To: Users of SFI Specs 10.2  
From: SFI Foundation, Inc.  
Subject: Spec 10.2A, Revision, effective December 3, 2021

The above referenced SFI Specs for Altered Car Roll Cage, 6.00 – 7.49 Seconds E.T. have been revised, effective December 3, 2021. The revised version is designated as SFI Specs 10.2A and is immediately available from SFI for use by sanctioning bodies and chassis builders.

**Section III.1.b:**

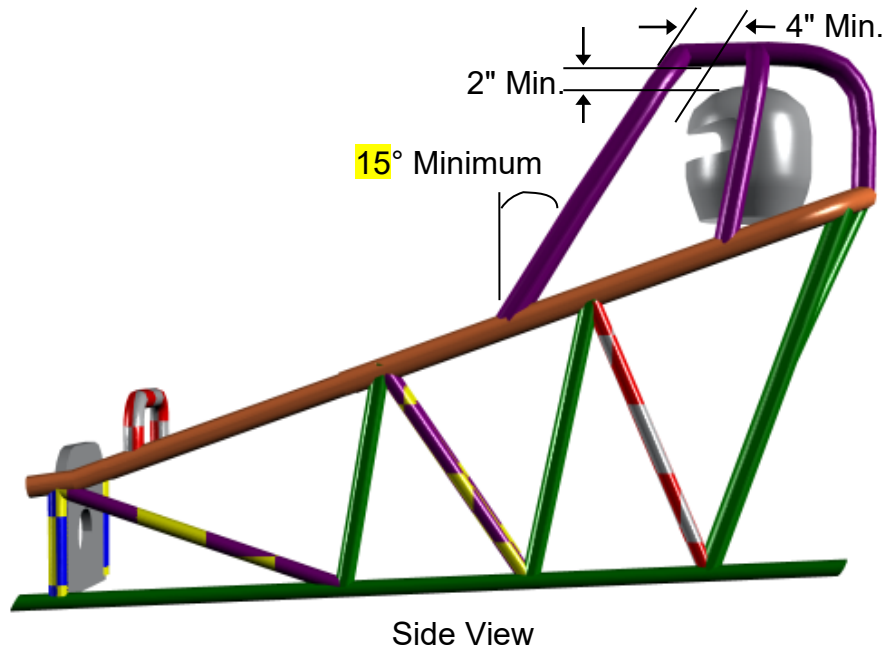
- b. The forward roll cage hoop (#1) must be installed to the upper frame rails (#4) at a minimum angle of **15°** from vertical.

**Interior Reinforcement Tube**  
Seat upright is behind roll cage hoop

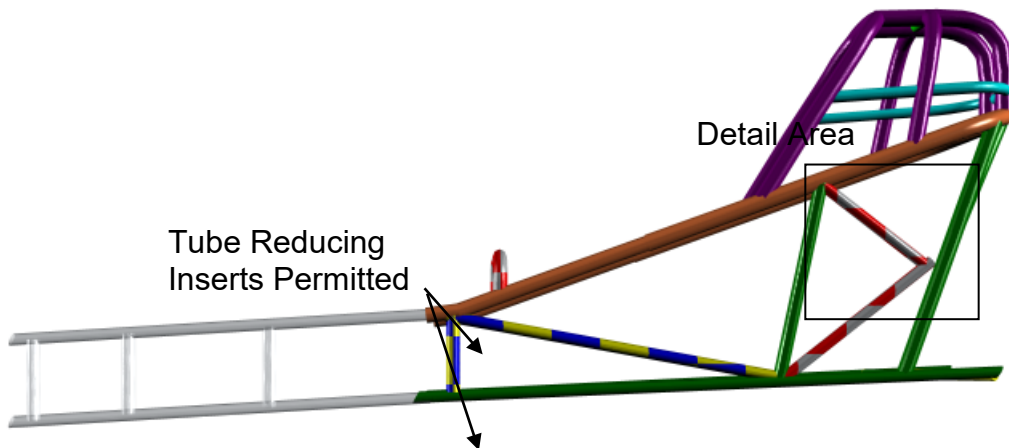
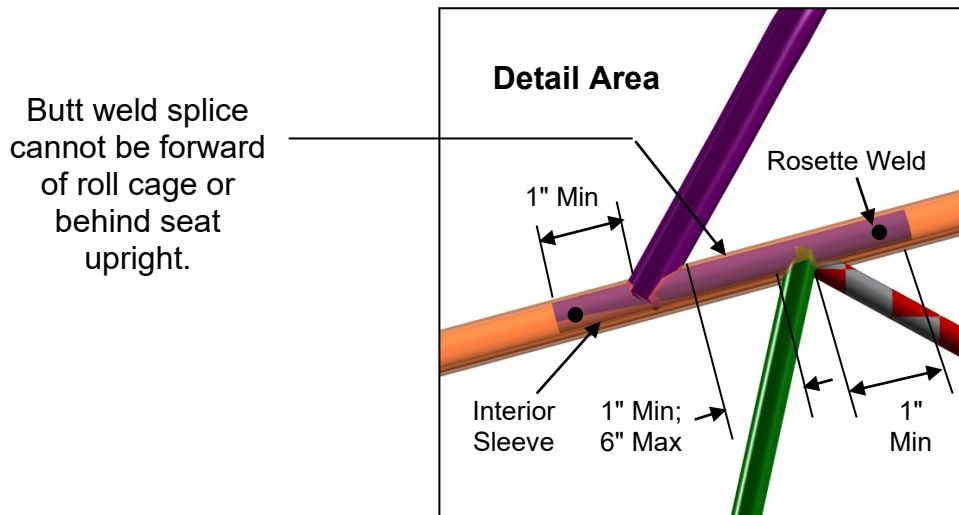
The forward edge of the seat upright (#10) must be at least one (1) inch (25.4mm) but not more than six (6) inches (15.2cm) behind the rear edge of the main roll cage hoop (#1) with the reinforcement tubes (#6) extending one (1) inch (25.4mm) minimum ahead of the forward edge of the forward roll cage hoop (#1) to one (1) inch (25.4mm) minimum behind the rear edge of the forward seat upright (#10).

Butt weld splice cannot be forward of roll cage or behind seat upright.

The interior reinforcement tubes must extend one (1) inch (25.4mm) minimum ahead of the forward edge of the forward roll cage hoop to one (1) inch minimum behind the rear edge of the forward seat uprights.

**Interior Reinforcement Tube**  
Seat upright is in front of roll cage hoop

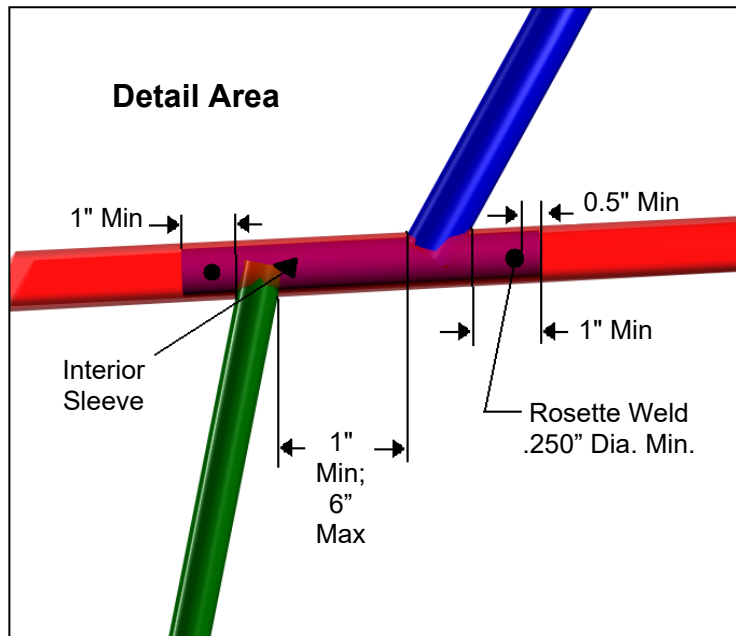
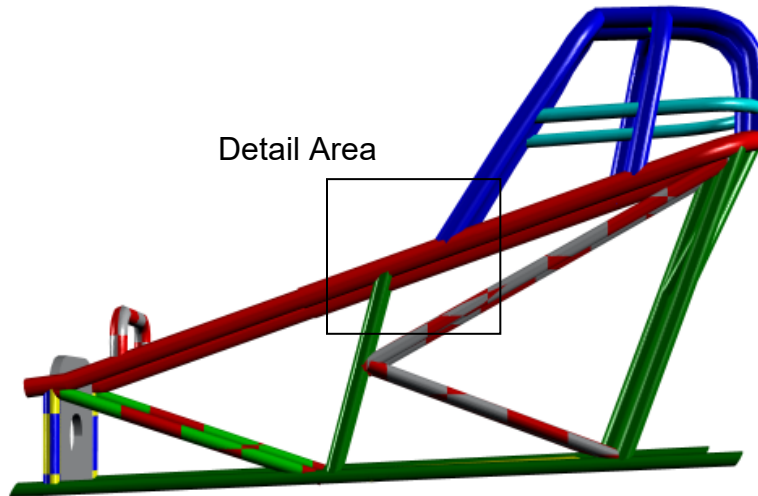
The rear edge of the seat upright (#10) must be at least one (1) inch (25.4mm) but not more than six (6) inches (15.2cm) in front of the forward edge of the forward roll cage hoop (#1) with the reinforcement tubes (#6) extending one (1) inch (25.4mm) minimum ahead of the forward edge of the seat upright (#10) to one (1) inch (25.4mm) minimum behind the rear edge of the forward roll cage hoop (#1).

Butt weld splicing of the upper frame rails to the shoulder hoop(s) is permitted between the main roll cage hoop and the forward seat uprights. If butt weld splicing is used here, interior sleeve(s) are required, extending a minimum of three (3) inches (7.6cm) on each side of the seam. The interior reinforcement tubes (#6) and the butt weld interior sleeve(s) may be one and the same if the minimum dimensions of each and all are met. Butt weld splicing of the shoulder hoop(s) (#3) is also permitted in the rear center. If butt weld splicing is used here, an interior sleeve is required.
